KIT-304-1

TITLE: KIT 304-1

I. This modification affects all model STR-2 receivers. It involves changes to the I.F. board A4020B to improve the gain stability, and AGC action.

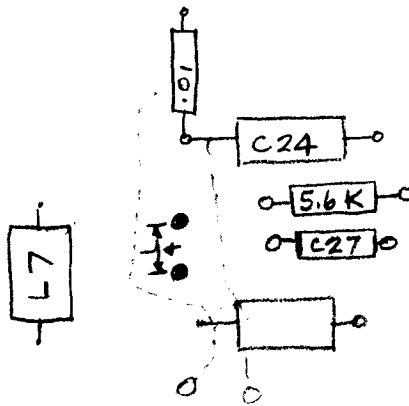
4. Mount the 5.6K ohm resistor, Item 10, across diode CR1805. Solder it.

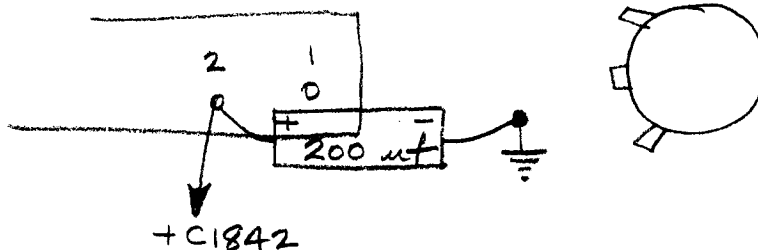
10. Connect positive of 200 mf, electrolytic cap, Item 12, terminal strip #2. Solder a lead from terminal #2 to positive side of C1842. The negative side of C1843, 200 mf ELECT. CAP., is soldered to grounding post near variable squelch pot.
